Subject: Application for Renewal and Revision to Certificate of Compliance No. 9233 for the Model No. TN-RAM Transportation Packaging, Supplement to Response to Request for Additional Information (Docket No. 71-9233, TAC Nos. L25001 and L25002)

RAI Responses

**Changed Pages, TN-RAM SAR, Revision 15A
(Non-Proprietary)**

Figure 5-8
Dose Rate Profile at 2 m from Vehicle Side, Homogenized Source

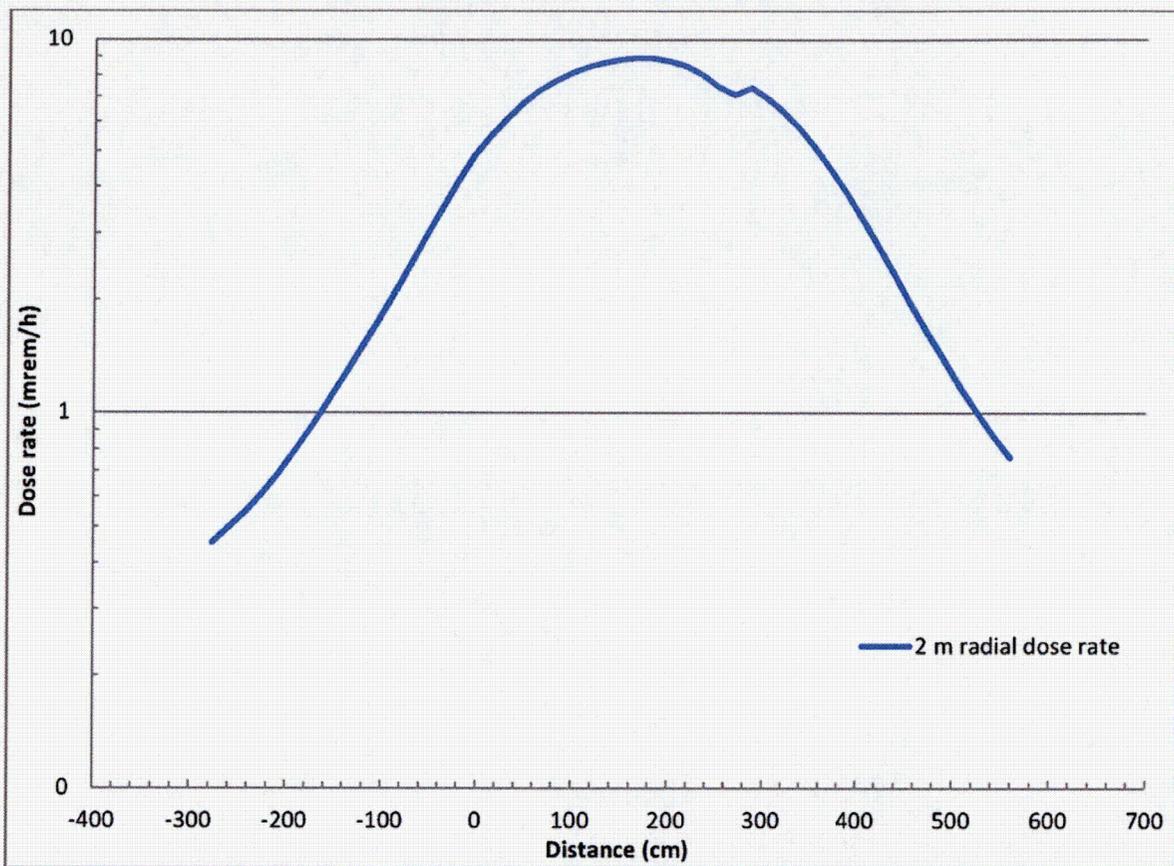
Justify the size of the segments for the mesh tallies (detectors) used to evaluate the dose rates and justify that streaming was adequately accounted for under NCT and HAC.

Section 5.4.4 states: *“Radial tallies are segmented axially between 20 and 22 cm. Axial tallies are segmented radially approximately 22 cm.”* The applicant should justify that these segments are small enough to evaluate the effects of streaming. The staff is interested in the area in the axial and radial directions between the lead shielding in the cask body and the lid. The area above the lead shielding is of specific importance during HAC shielding evaluation where there is lead slump. In discussing streaming effects, the applicant should justify that the source configuration selected for this evaluation gives the highest dose rate (i.e. a more concentrated source, like the disk source at the top would exaggerate the effects of streaming more than the homogenous source, etc.).

The dose rates presented in Table 5-15 are sufficient enough to determine streaming exists in the model. Section 5.4.4.9 has been added to the TN-RAM SAR, in response to this question, to explicitly discuss streaming. Sections 5.1.2, 5.3.1, 5.4.4, and Table 5-15 have been revised with conforming changes in response to this RAI.

At a distance of 2 m from the side of the vehicle, the radiation due to streaming does not correspond to the maximum dose rate location and the homogenized source is the bounding configuration. This effect may be observed in Figure 5-8, which is a plot of the 2 m side dose rate as a function of axial location for the homogenized source. The maximum 2 m dose rate occurs at $z = 167$ cm (8.91 mrem/hr), although a distinct discontinuity in the dose rate is observed at $z = 286$ cm (7.39 mrem/hr). This discontinuity is due to streaming over the lead, although the resolution of the mesh tallies is sufficient to resolve the streaming effect. Therefore, the effect of streaming is properly accounted for in the dose rate results.
